15 SUB2013-00130

F & S SUBDIVISION, RESUBDIVISION OF LOT 1

DETAIL SITE PLAN

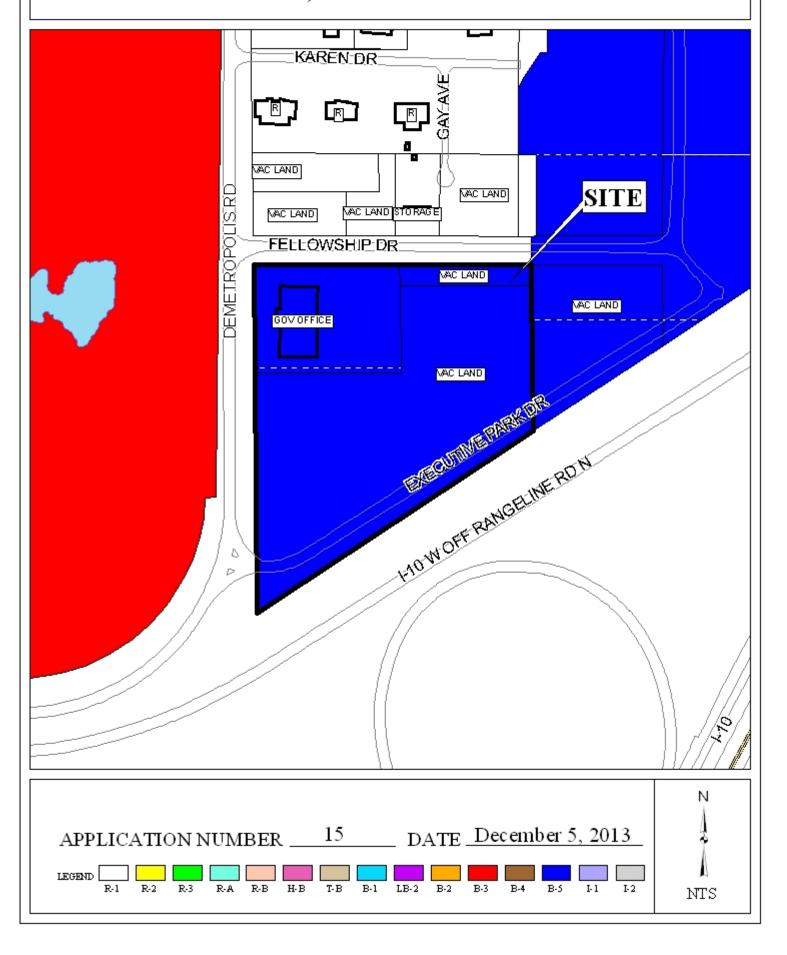
The site has two street corners (Demetropolis Road and Fellowship Drive, and Demetropolis Road and Executive Park Drive) where there has been no corner radius dedication. Traffic Engineering has determined that corner dedications would be required at these intersections. Therefore, the plat should be revised to indicate a 25' radius corner dedication at both intersections.

5) placement of a note on the Final Plat stating that Lot 2A is limited to two curb cuts to Demetropolis Road, with the size, design, and exact location to be approved by Traffic Engineering and conform to AASHTO standards;

- 6) dedication to provide a 25' radius curve at the intersection of Demetropolis Road and Fellowship Drive;
- 7) dedication to provide a 25' radius curve at the intersection of Demetropolis Road and Executive Park Drive;
